Comments to Doc. TRANS/WP.29/GRSP/2003/7

Transmitted by the expert from Germany

Explanatory note to paragraph 5.1.1.:

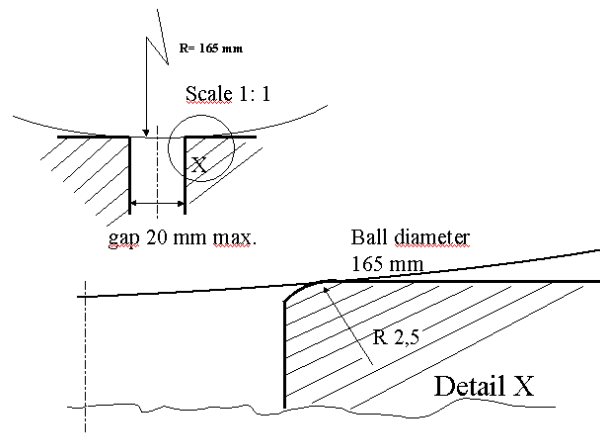
A sharp edge is an edge of a rigid material having a radius of curvature of less than 2.5 mm except in the case of projections of less than 3.2 mm, measured from the panel. In this case, the minimum radius of curvature shall not apply provided the height of the projection is not more than half its width and its edges are blunted.

This simplification as shown in the sketch above made it necessary to explain, that **in a new explanatory note to paragraph 2.18.**, that in case of **gaps within the head impact test area** the edges has **been rounded by a minimum radius of 2.5 mm** where the edges can be contacted statically and/or during the head impact test. All impact points shall be evaluated "during" and after the energy dissipation test. If the technical service can observe an edge which has been contacted during the test the radius has been evaluated as "dangerous radius", if the edge has a minimum radius smaller than 2.5 mm. In addition the evaluation of g-level and g-duration time shall be made.

To simplify the evaluation if an edge - contacted during the impact test - is dangerous or not, the vehicle manufacturer shall provide as minimum safety provision a radius of at least 2.5 mm.
